Grimes Planning and Zoning Commission Meeting February 4, 2025 @ 5:30 PM

1. Legacy at James Street Plat 2 Preliminary Plat
2. Legacy at James Street Plat 2 Lot 1 Site Plan
3. Legacy at James Street Plat 2 Final Plat

Legacy at James Street
Plat 2 Lot 1 Site Plan

RE: Legacy at James Street Plat 2, Lot 1 Site Plan

EXTERIOR BUILDING
ELEVATIONS

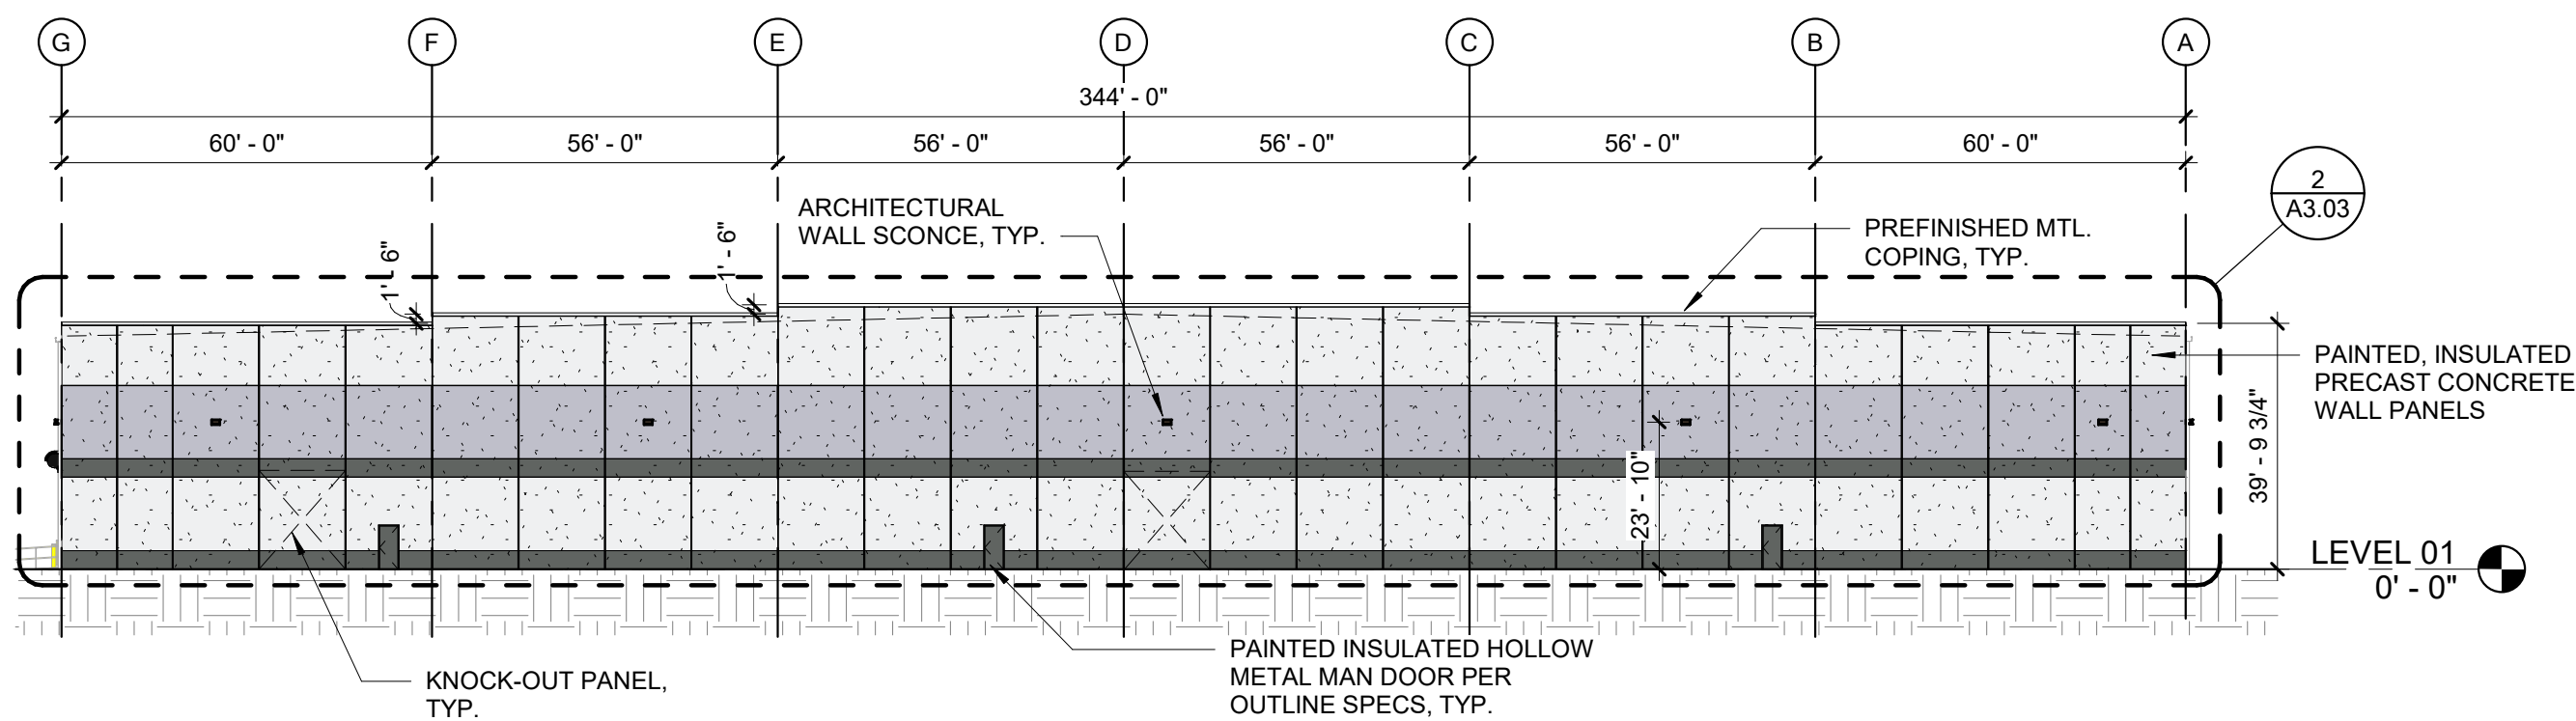
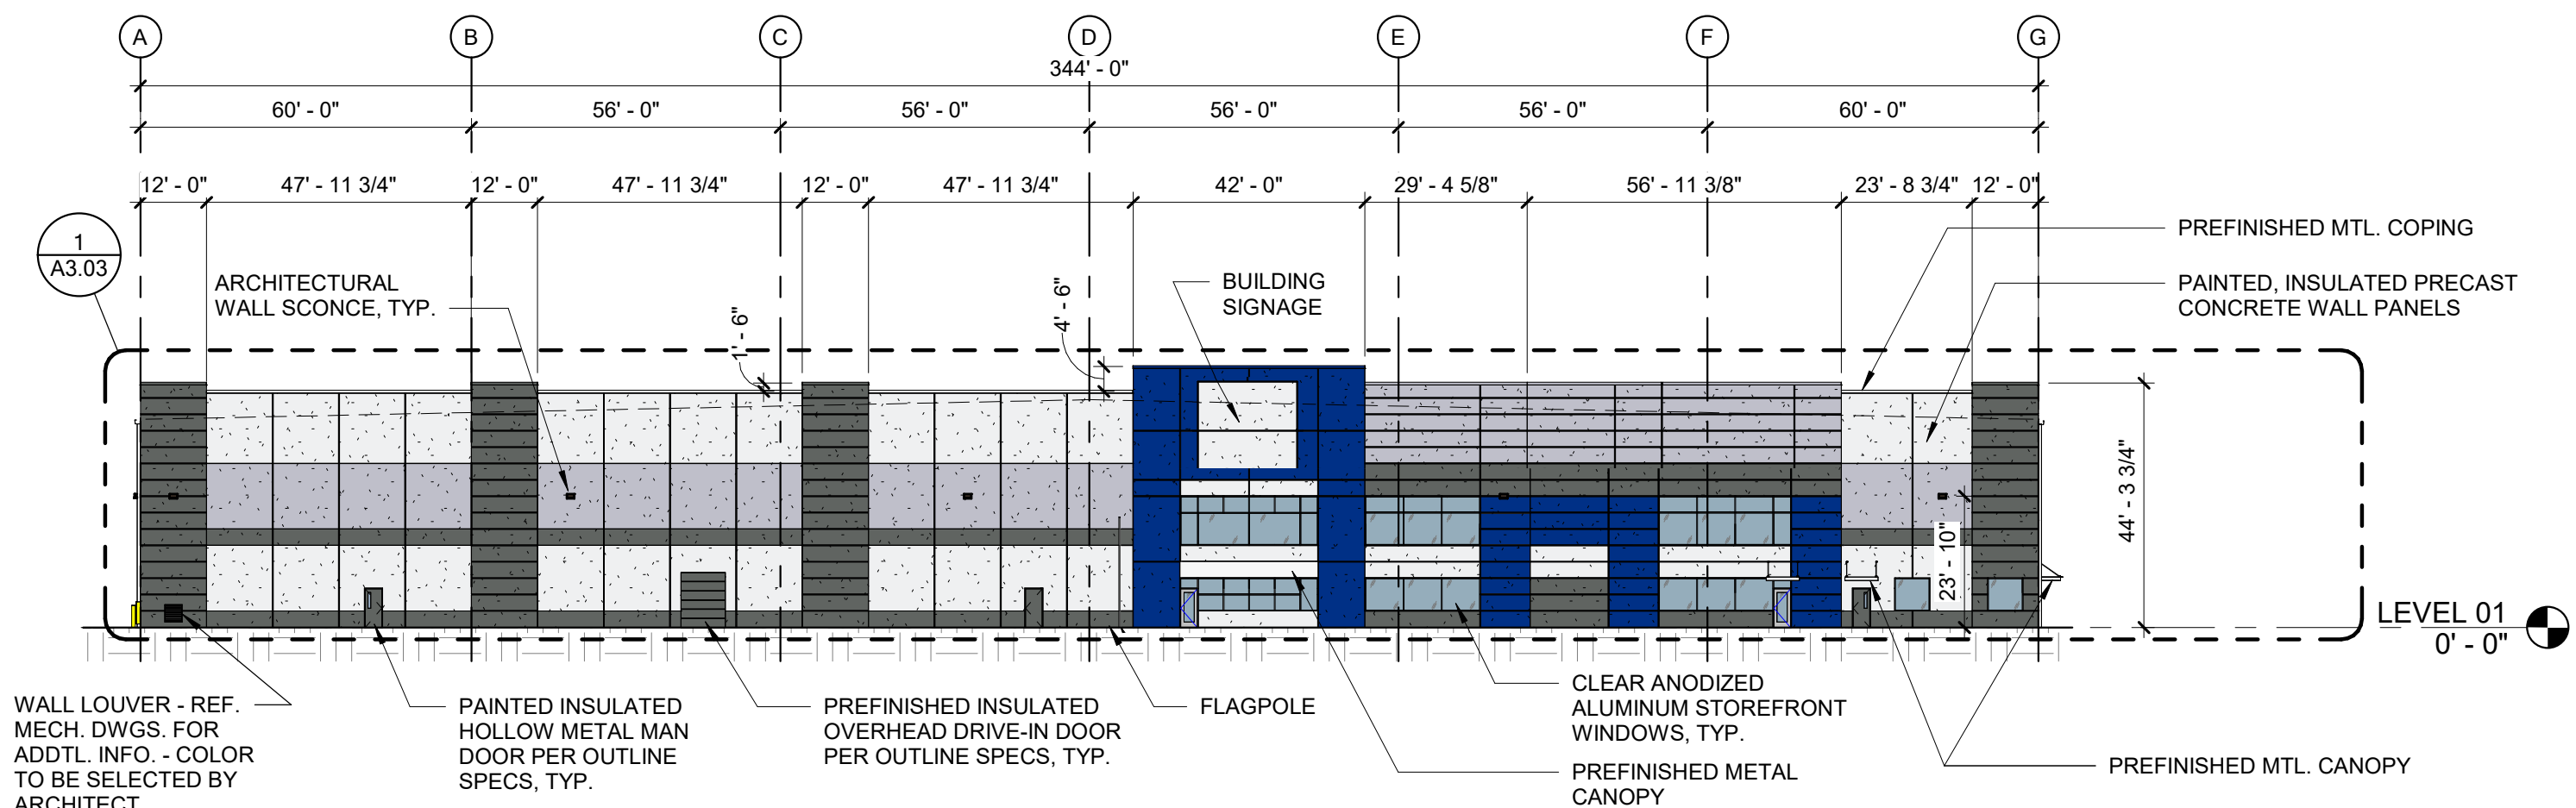
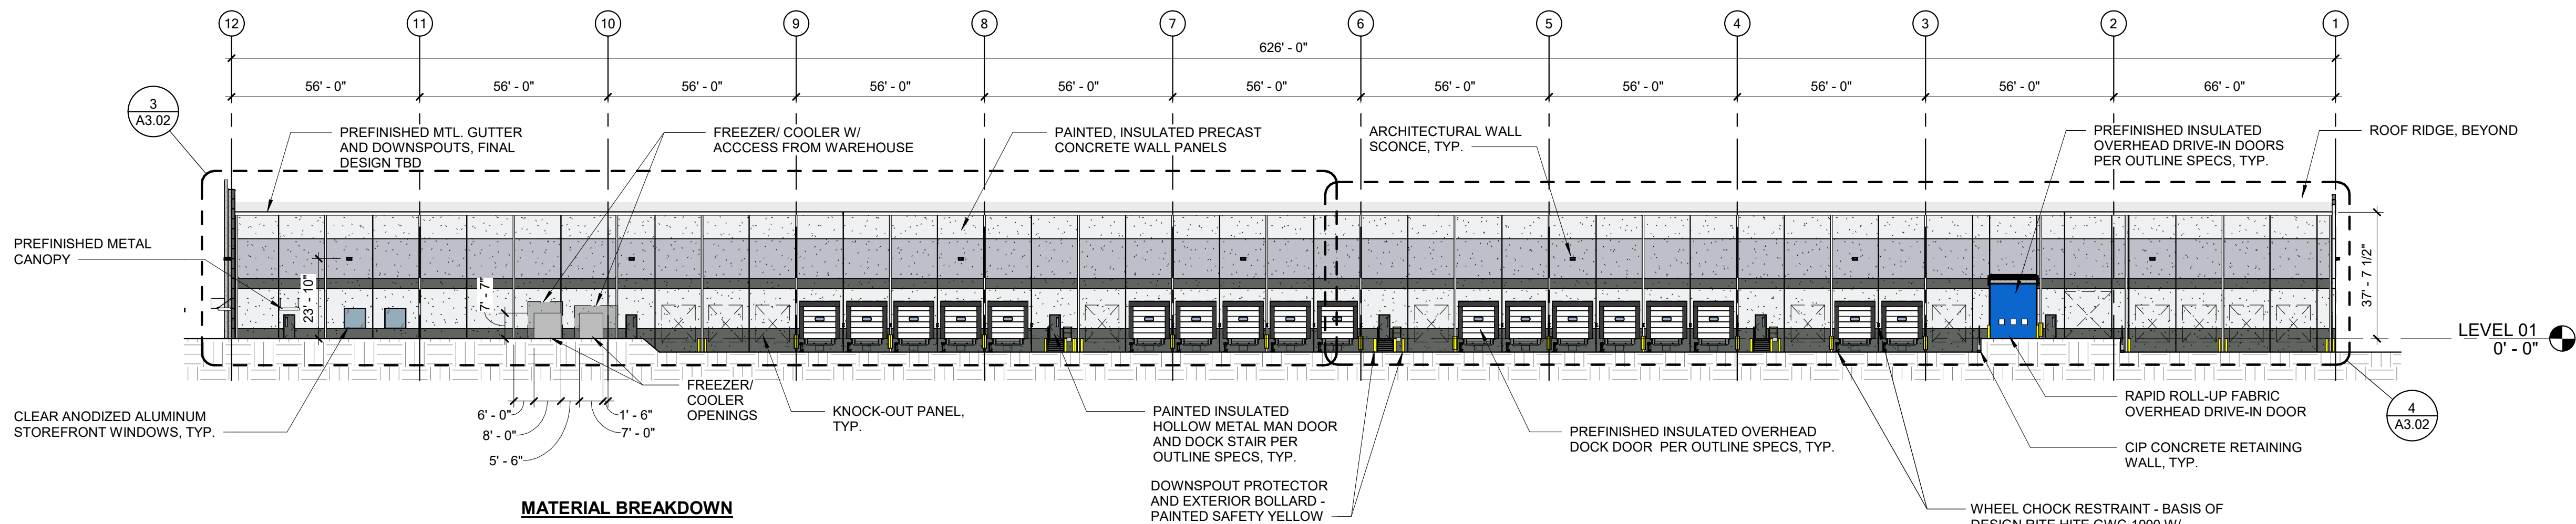
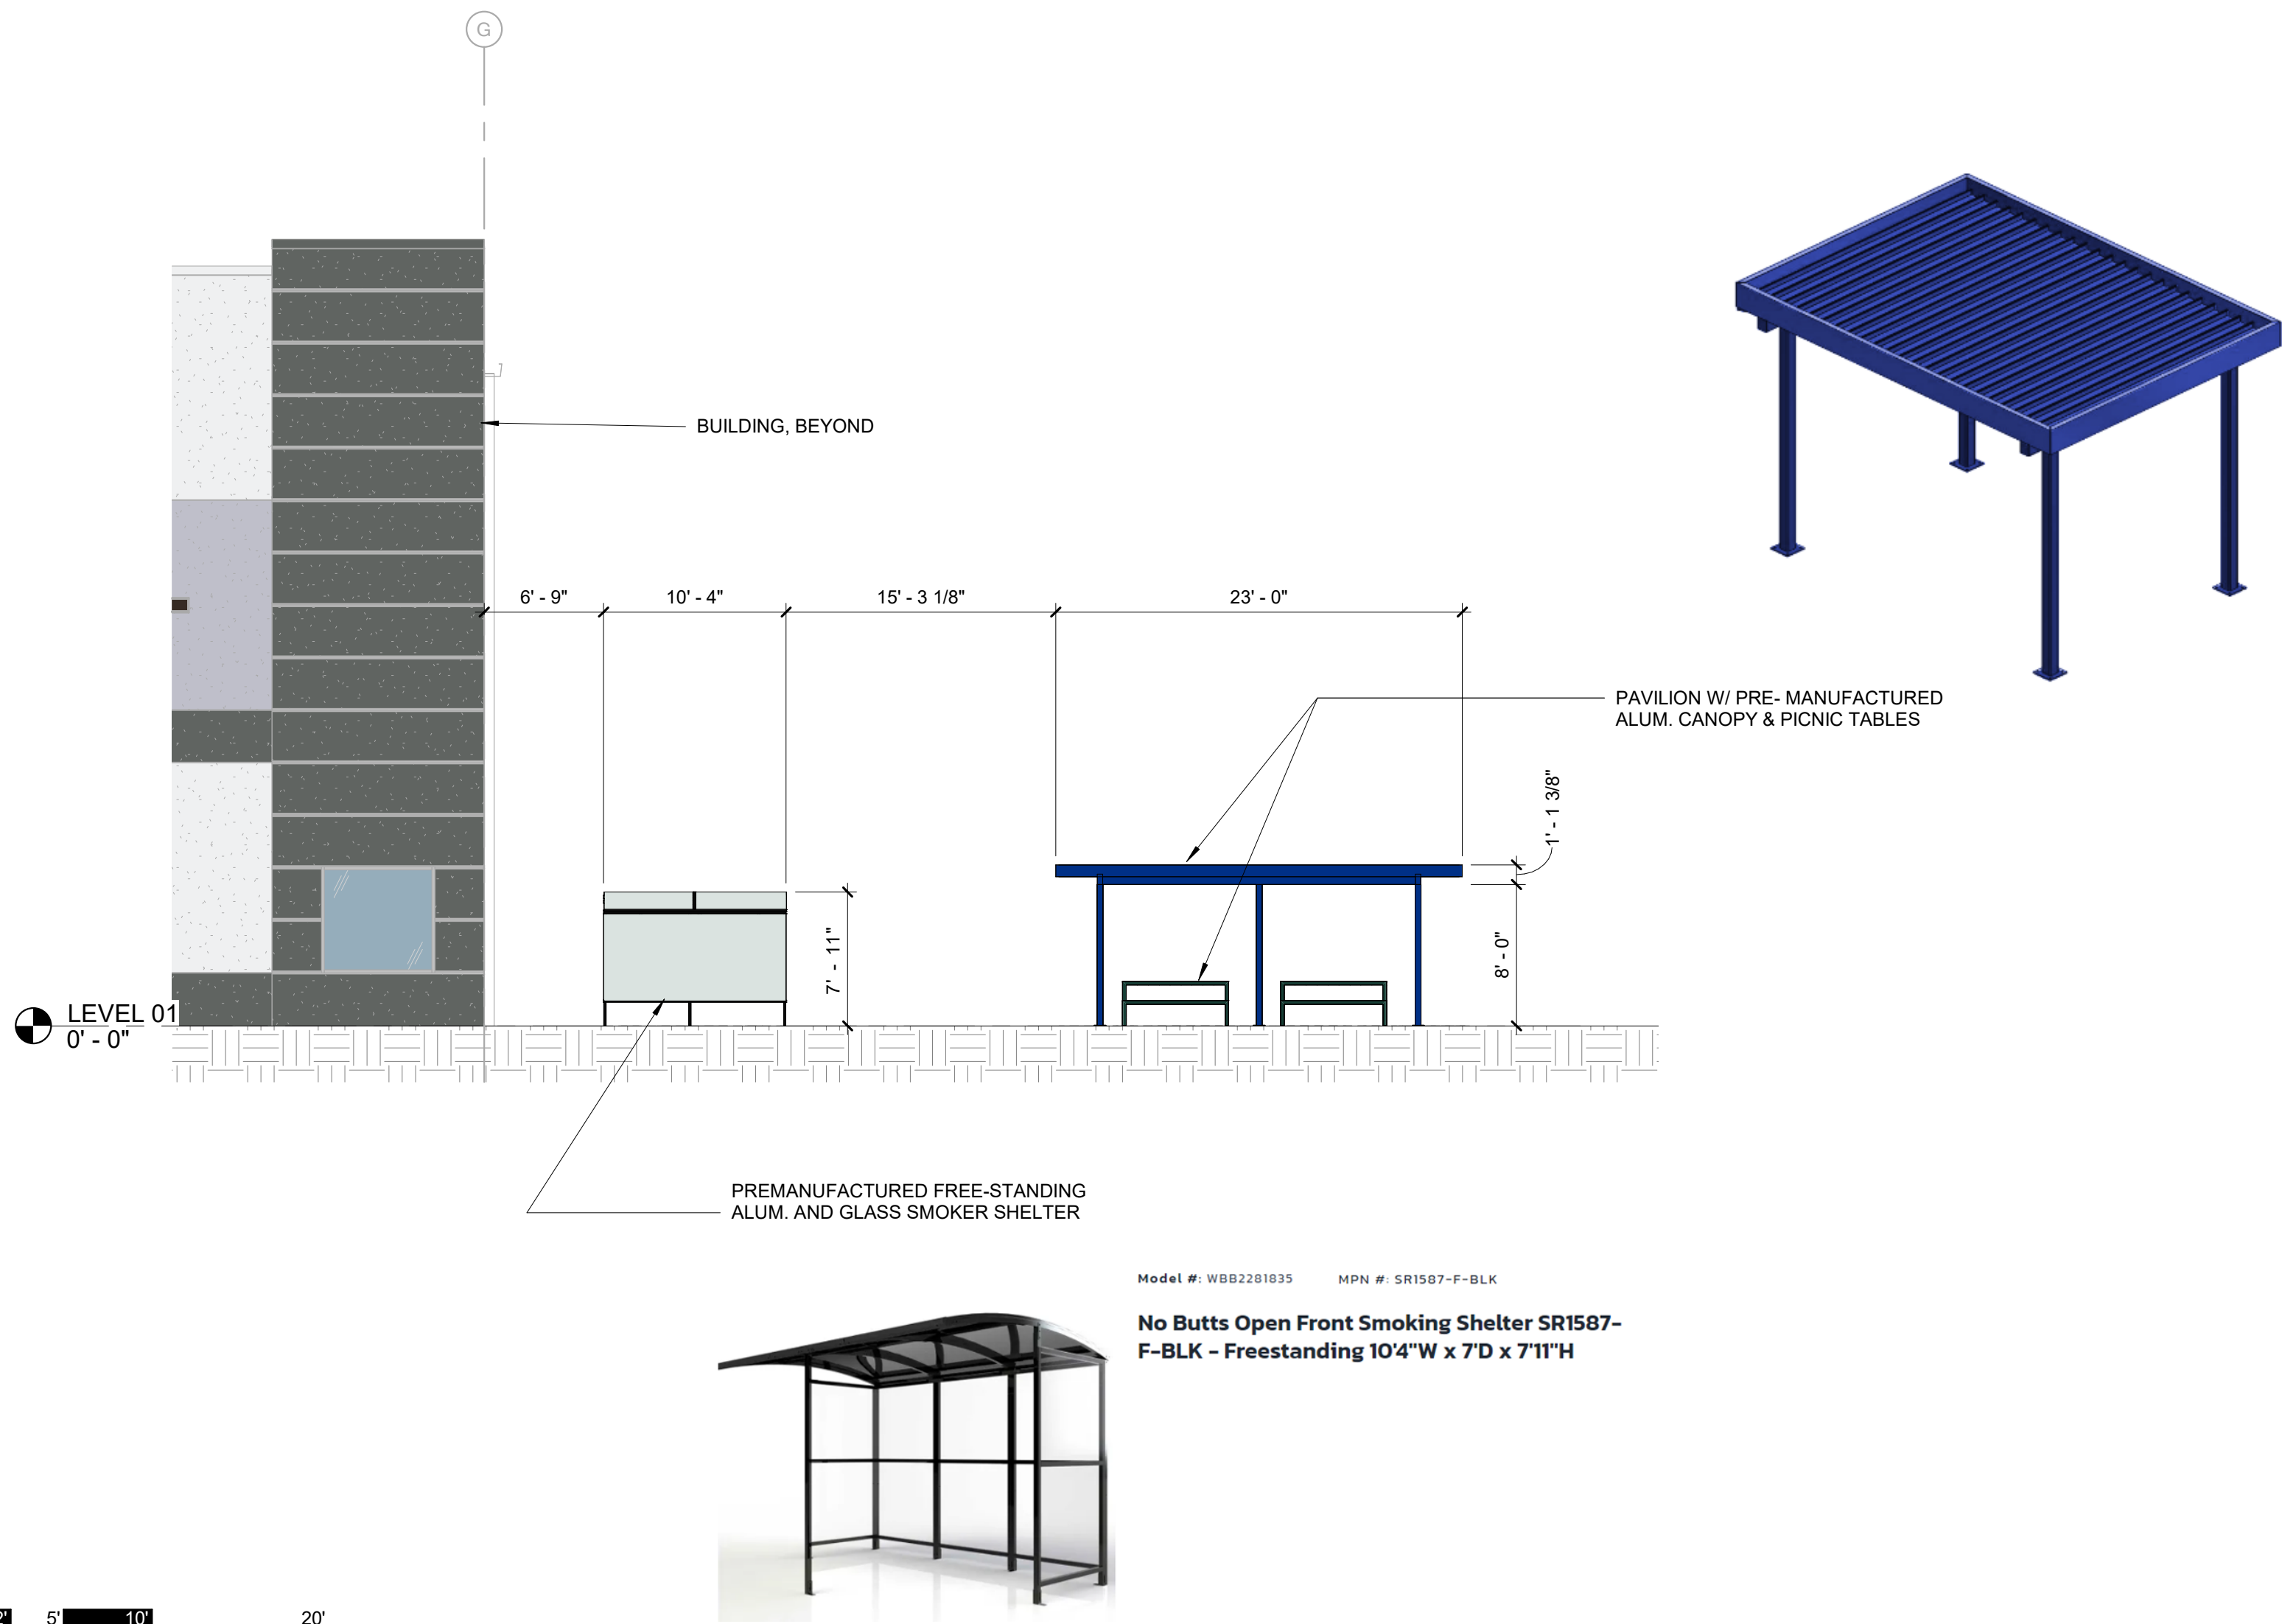
3. ~~Please remove accessory structures from the overall elevations and provide elevations for them on a separate sheet.~~
4. Note that a 4/5 Council vote of approval for the site plan is required if the building is not 100% masonry. The Council has given approval to precast projects nearby that have been in the overlay so this should not be an issue.

6. ~~Please provide dumpster enclosure elevations if the dumpsters are planning to be stored outside in enclosures.~~
7. Please show any rooftop equipment that is proposed on the elevations. Rooftop equipment will need to be screened effectively from adjacent properties and streets per the city code.
